**Assessment of Twenty-Four (24) Protected-Size Trees  
at and adjacent to  
16010 Winterbrook  
Los Gatos, California**

Prepared for:  
Ryan Safty, Associate Planner  
Town of Los Gatos Community Development Department  
110 E. Main Street  
Los Gatos, CA 95030

Report by CTA  
7/20/2020  
Revised 8/12/2021

2f. SANITARY SEWER (SS) PIPE & STORM DRAIN (SD) PIPE ADJUSTMENTS:

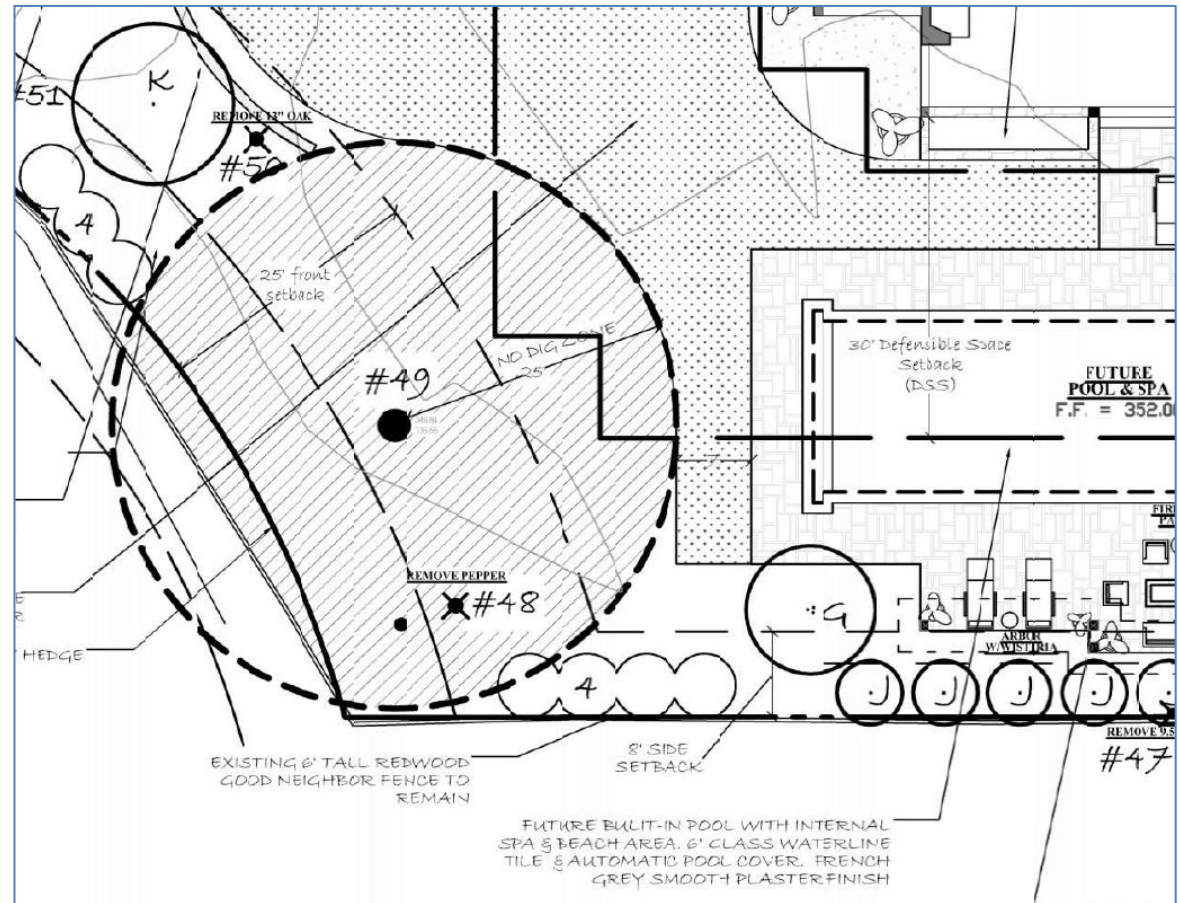
Per the CTA's review of the most recent 4/16/2021 version of the grading and drainage plan sheet 4 of 6, the following plan adjustments are suggested:

- Relocate the proposed storm drain pipe trench to at least 10 feet offset from trunk edge of oak #41, or use trenchless directional bore technology to avoid trenching altogether.
- Relocate the proposed sanitary sewer pipe trench to at least 10 feet from trunk edge of oak #41, and 6 feet from trunk edge of oak #57, or use trenchless directional bore technology to avoid trenching altogether.

## 12.0 Tree Location & Protection Fence Map Mark-up by the Applicant and the CTA

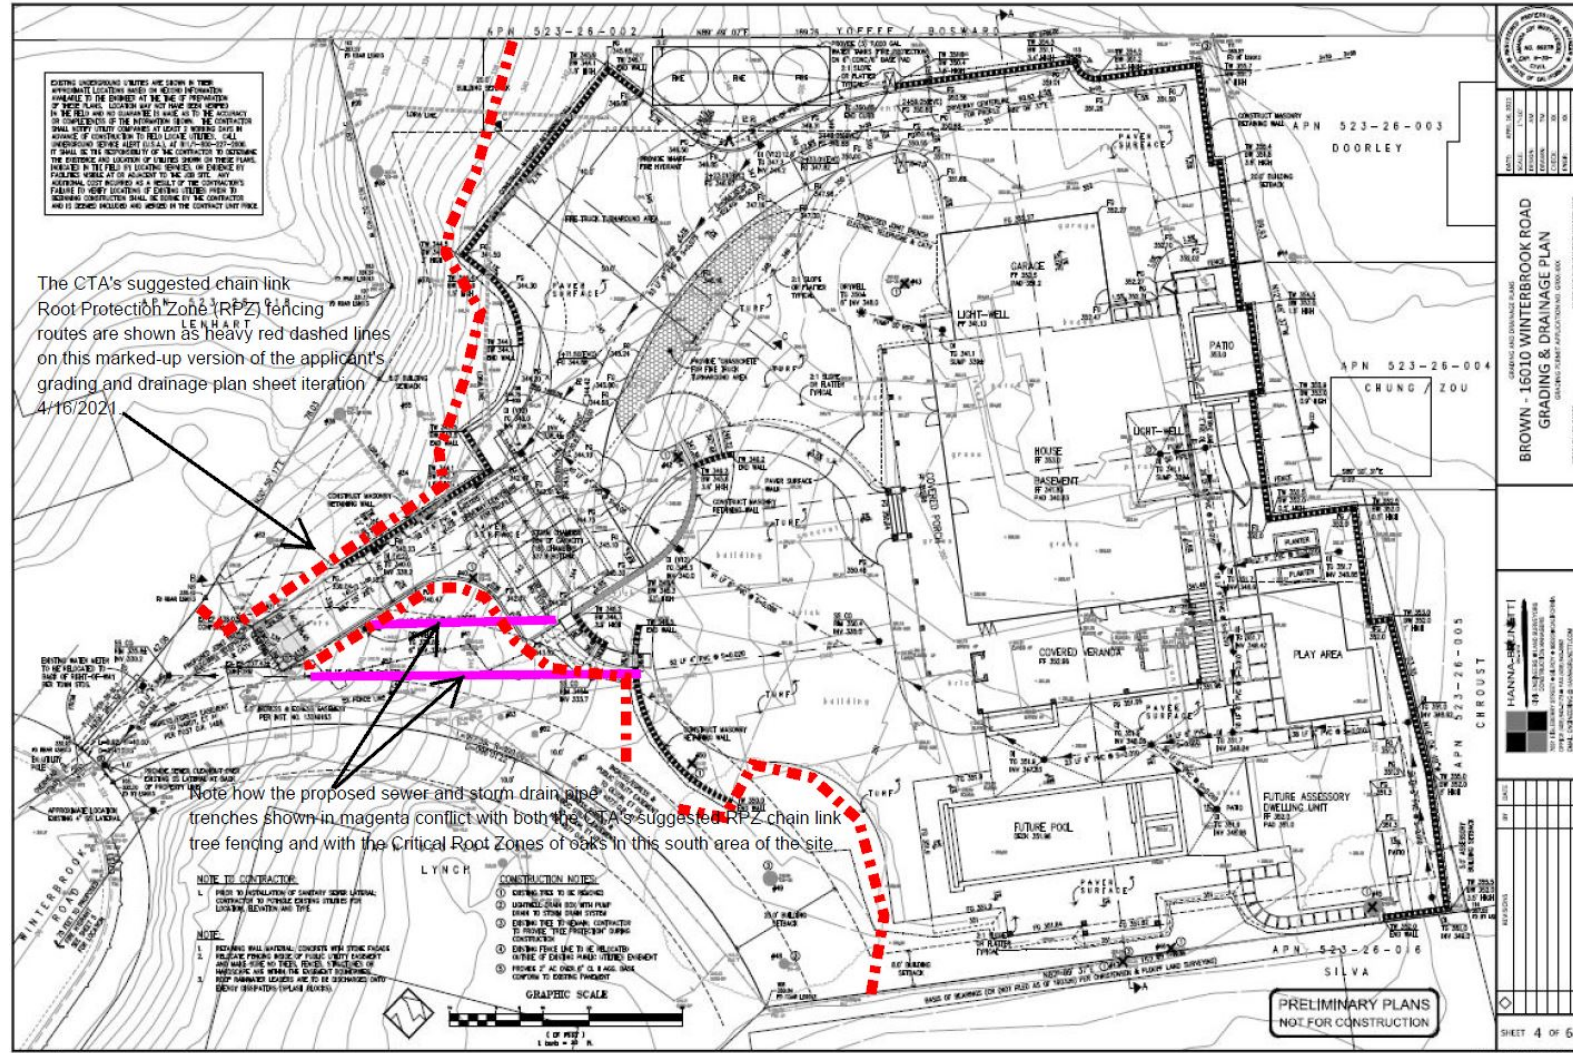
The CTA marked up the applicant's grading and drainage plan sheet 4 of 6, dated 4/16/2021.
